**PLS RESPONSE TO MDEQ JUNE 19, 2008 MEMO
REGARDING REVIEW OF EVERGREEN SYSTEM
CAPTURE EFFECTIVENESS**

August 7, 2008

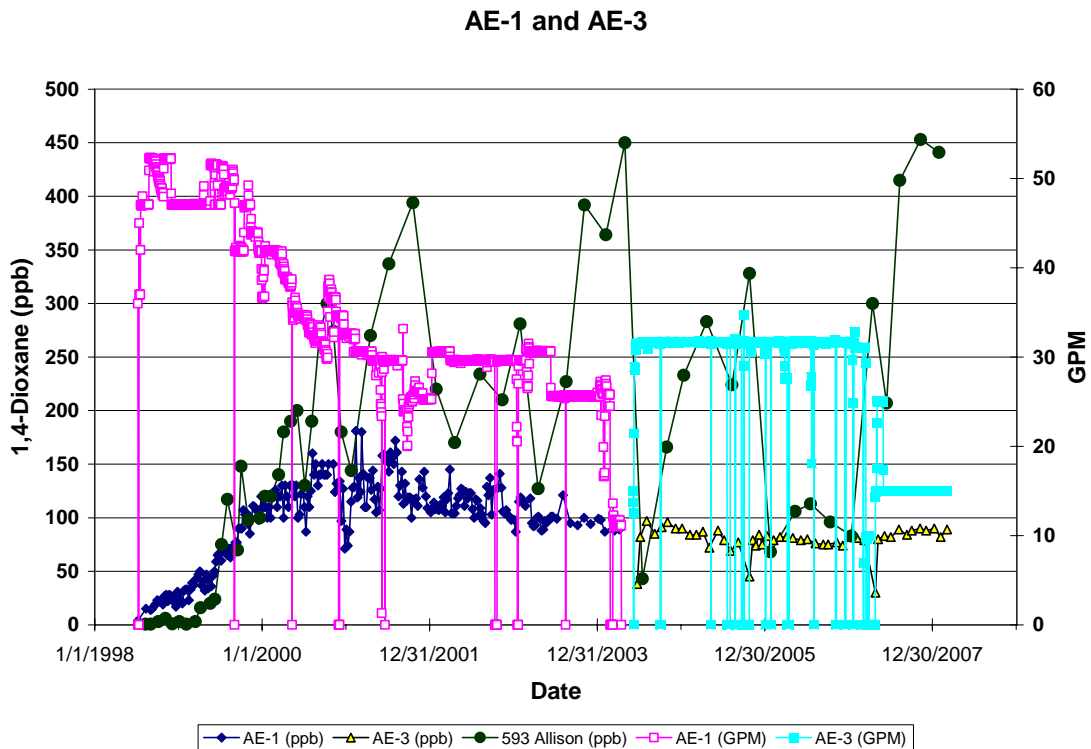
Figure 7 shows 1,4-Dioxane concentrations in sampled wells between Evergreen and Allison and the pumping rate for well LB-2. After well LB-2 was shut-down, the 1,4-Dioxane concentrations in wells at 2805 Dexter, MW-BE-1s, and 593 Allison increased. It appears that the change in the LB-series well system has resulted in a release of higher concentration 1,4-Dioxane that has migrated to Allison Street.

PLS Response – (See the above comment regarding the appropriate compliance point for determining plume containment.) 2819 and 2805 Dexter did appear to respond to LB-2 being taken offline and replaced by LB-3. This is not surprising since these are the

closest wells to the LB wells. But again, this “response” is not an indication that the shift caused a portion of the plume to escape. Both of the Dexter wells are in the immediate vicinity of the LB extraction wells. These residential wells and any nearby 1,4-dioxane are certainly within the capture zone of the LB extraction wells, regardless of the configuration. Again, the changes in concentrations in these are undoubtedly attributable to shifts in the groundwater flow caused by the change in purge well locations and/or purge rates. These changes do not suggest that the plume has escaped.

Concentrations at 593 Allison have been sensitive to changes in purge rates of the AE extraction wells for the same reasons. A graph of 1,4-dioxane concentrations at this well location are shown below. It is clear that the concentrations at this location have varied considerably over time. The MDEQ has no scientific basis to relate any changes at this location to some “release of higher concentrations of 1,4-dioxane that has “migrated” to Allison Street.” A simpler explanation is that the concentrations at 593 Allison correlate to extraction at the AE locations (note on the graph below that when AE-1 and AE-3 flow changes, there is a corresponding change in 1,4-dioxane concentrations at this well). This is another example of how subtle changes in hydraulic gradients, in this case by flow rate changes in the AE area, can cause a trend change. The MDEQ’s interpretation that these changes are related to an escaping plume “migrating” from the LB area is fundamentally flawed and cannot be supported.

Plot of Extraction Rate (gpm) and 1,4-Dioxane Concentration at AE-1 and AE-3

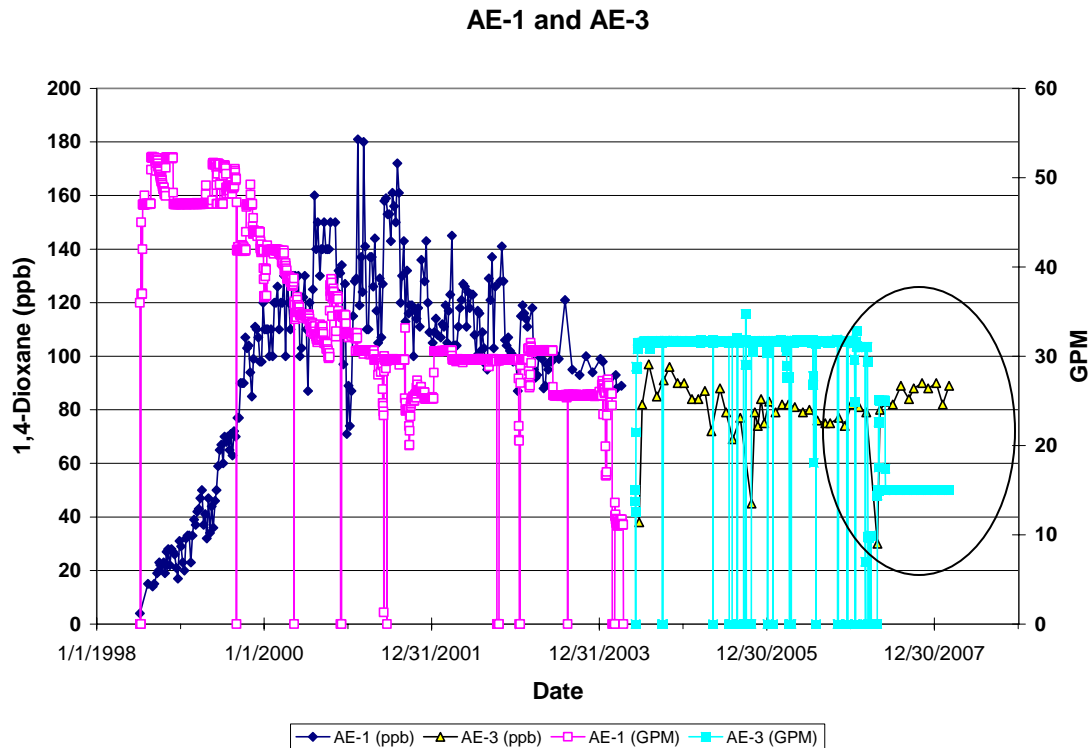
The mass of 1,4-Dioxane removed per gallon extracted from the Allison-series wells is shown in Figure 8. The mass removal rate, while low, had been fairly consistent until mid-2003 when removal rates started declining. Throughout 2006, the removal rate remained fairly consistent and then started increasing in 2007. The concentrations of 1,4-Dioxane in the AE-series wells and the pumping rates at LB-2 and total LB-series pumping are shown in Figure 9. There has been an increase in 1,4-Dioxane concentrations at AE-3 since early 2007, and there had been a continuous increase in 1,4-Dioxane at AE-2 until sampling stopped in 2006. It's our opinion that the increase in mass removal rates and 1,4-Dioxane concentrations is the result of a partial loss of containment by the LB-series wells.

PLS Response – *The MDEQ's theory ignores the obvious explanation for the minor increased concentrations and mass removal rates observed in 2007. The flow rate of AE-3 was reduced during 2007. By reducing the flow rates, the concentration in AE-3 increased very slightly. Increases in contaminant concentrations are typical when flow rates in extraction wells since there is less dilution in the capture area (the influent concentration for purge wells is often inversely proportional to flow). This is illustrated in the graph below. The slight increase in 1,4-dioxane concentration simply resulted in a slightly increased mass removal efficiency (when normalized to gallons purged, as the MDEQ did in their analysis- lbs/day/gallon).*

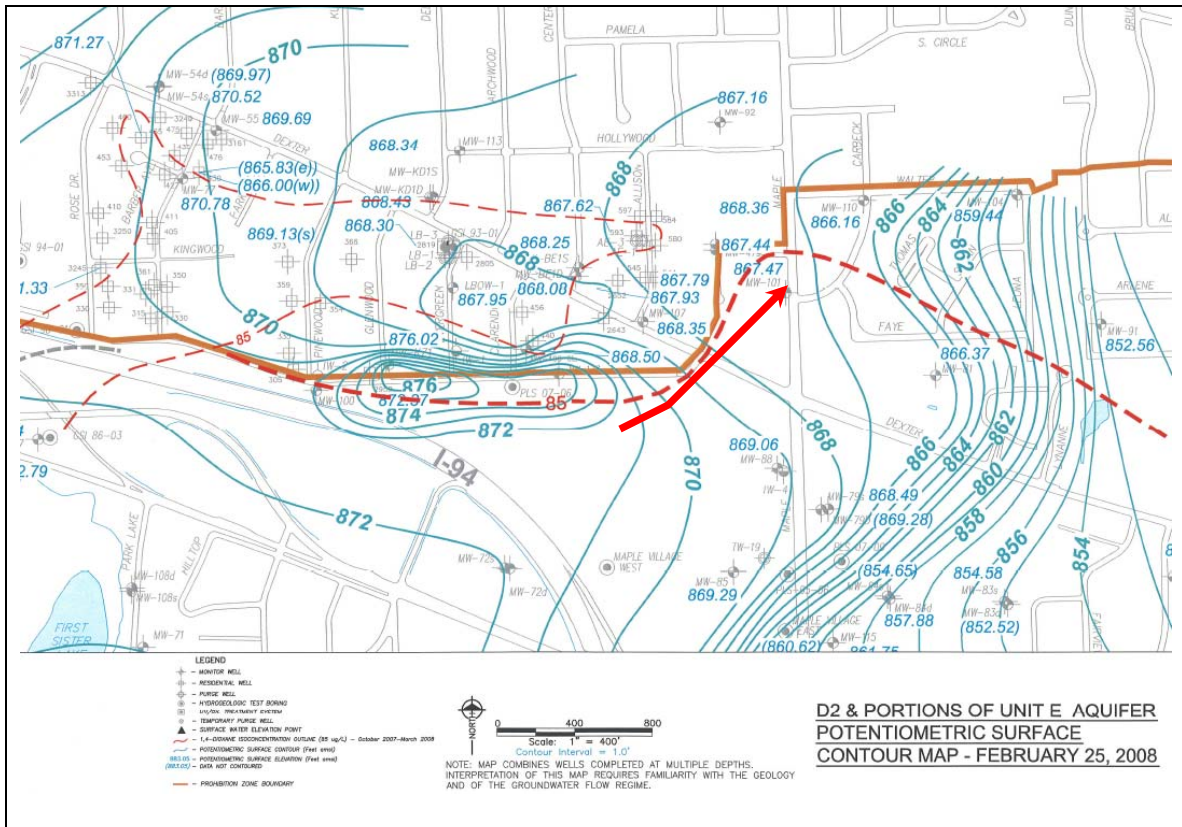
Figure 10 shows the 1,4-Dioxane concentrations in Allison Street residential wells. As shown in this figure, except for the residential wells at 544, 545, and 593 (shown in Figure 7) Allison, all other previously sampled wells have been dropped from the sampling network. There had been a steady increase in concentrations in wells at 580, 584, and 597 Allison between early 1997 and late 2003 or 2004 when sampling each of these wells stopped. The reason for this increase is not known. The 1,4-Dioxane concentrations at 544 Allison decreased between 2001 and 2003. However, since early 2005, the 1,4-Dioxane concentrations in the wells at 544 and 545 Allison have increased steadily. This increase appears to be the result of higher 1,4-Dioxane concentrations migrating past the LB-series wells toward Allison Street.

PLS Response – (See the above comment regarding the appropriate compliance point for determining plume containment.) 544 and 545 Allison are still in low ppb range, and changes at these locations are not an indication that the plume is not contained by the LB or AE wells. Additionally, these “increases” started in spring 2005, long before LB-2 was taken offline. Therefore, that shift in purge locations cannot be the control mechanism.

A simpler explanation for the increases at 544 and 545 Allison is that AE-3 began to operate more intermittently during that period (see earlier graph). Another plausible explanation is that any increase in the concentrations at these wells is due to contribution from the Unit E. Either of these explanations is more likely than the MDEQ’s hypothesis.

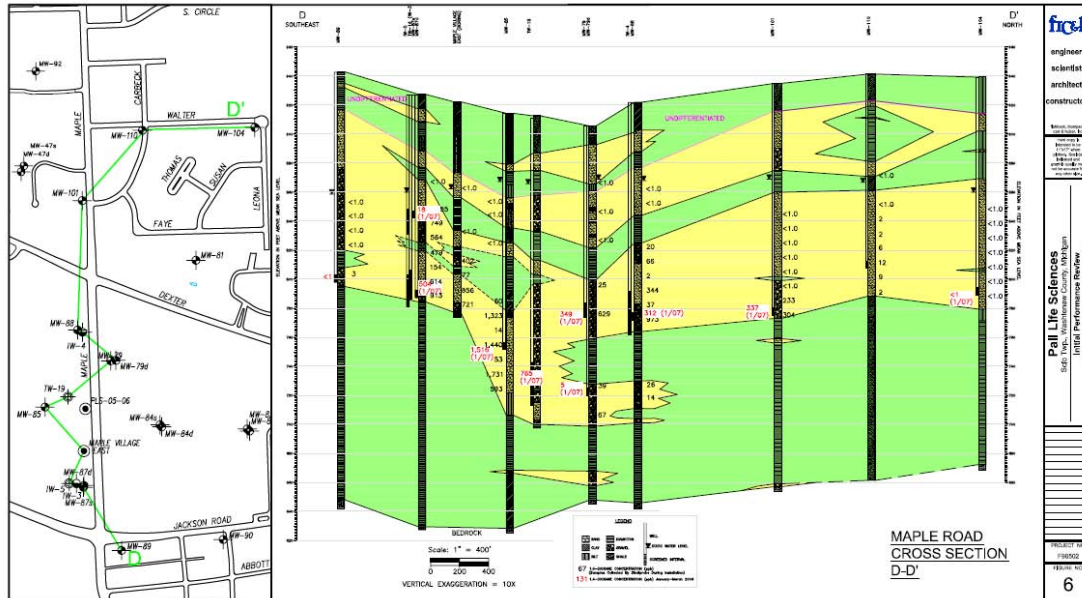
As for the area near the AE-series wells, there has been no good long-term sampling network east of Allison Street. PLS has relied on sampling the monitoring well clusters MW-47s and d to demonstrate containment of the contaminant plume. However, as shown in cross sections 08-07 and 08-03 (Figures 2 and 4 in the Valley Drive report), these wells are very shallow and were not installed using vertical aquifer sampling techniques. We cannot be certain that these well screens are placed in the proper vertical location, especially given the downward hydraulic-head gradient at this location and the elevated 1,4-Dioxane concentrations detected in the vertical aquifer sampling in the borehole for LB-3 and at well MW-101 (see Figure 2 in the Valley Drive report). There is no demonstrated “clean zone” (as drawn by FTC&H in all previous investigation or sampling reports) that would indicate that the 1,4-Dioxane detected at MW-101 is not the result of 1,4-Dioxane moving from Evergreen toward this well.

- 1. Groundwater flow in the combined Unit E/D2 hydrofacies is from the southwest, toward MW-101, suggesting the 1,4-dioxane at this location comes from Unit E to the southwest. This is shown on the map below:*

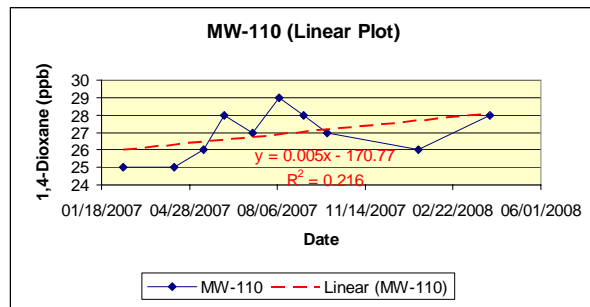
Figure 11 shows the 1,4-Dioxane concentrations in wells downgradient of Allison Street that were installed using vertical aquifer sampling, these are MW-92, MW-101, and MW-110. The concentrations in wells MW-101 and MW-110 have shown an increase since 2007. There has not been a similar increase observed at well MW-92. Wells MW-101 and MW-110 are located in a downgradient direction from extraction well AE-3. The increase in 1,4-Dioxane concentrations in these wells may be related to the increased 1,4-Dioxane concentrations migrating toward Allison Street from Evergreen and a

The table below shows the sampling results for MW-110 and a plot of these results. MW-110 has had a range in concentration values of approximately 4 µg/L, with initial concentrations at 25 µg/L (2/12/2007), the highest concentration at 29 µg/L (8/8/2007), and the most recent concentrations at 28 µg/L (4/4/2008). The very minor (4 µg/L) range of 1,4-dioxane concentration values at this location could be attributed to a variety of factors (e.g., sampling variation, analytical variation, seasonal trends, etc.), unrelated to changes in the Evergreen System.

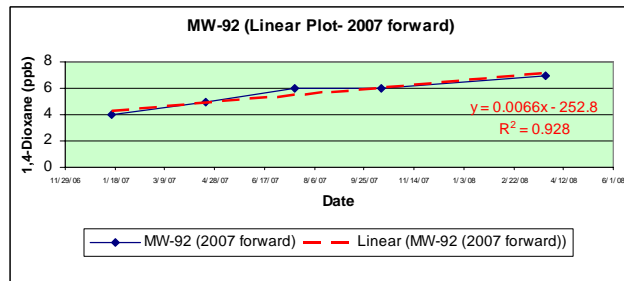
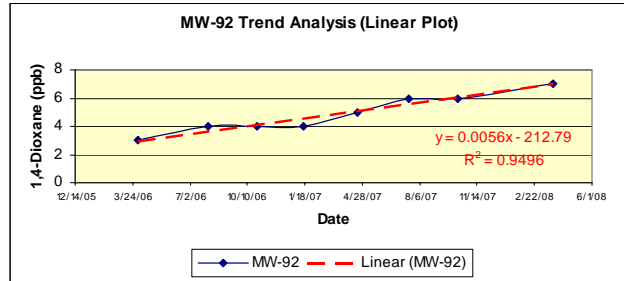
The MDEQ states "The concentrations in wells MW-101 and MW-110 have shown an increase since 2007. There has not been a similar increase observed at well MW-92." We are confused by this statement, since the "trend" in the data at MW-92 is no different than the "trend" at MW-110. The 1,4-dioxane concentrations have "increased" from 3 µg/L on 4/3/2006 to 7 µg/L on 3/25/2008. Thus concentrations in this well increased by the same 4 µg/L increment as the MW-110 concentrations did. The slope is positive,

suggesting a generally increasing trend, although the concentration values have a total range in values of only 4 µg/L. As is the case with MW-110, this minor increase of approximately 4 µg/L could be attributed to a variety of factors (e.g., sampling variation, analytical variation, seasonal trends, etc.). The table below shows the sampling results for MW-92 and associated trend graphs.

In reality, neither the MW-92 nor MW-110 exhibit any meaningful increasing trend, certainly nothing that is indicative of any failure of AE-3 to capture the leading edge of the Evergreen Plume.
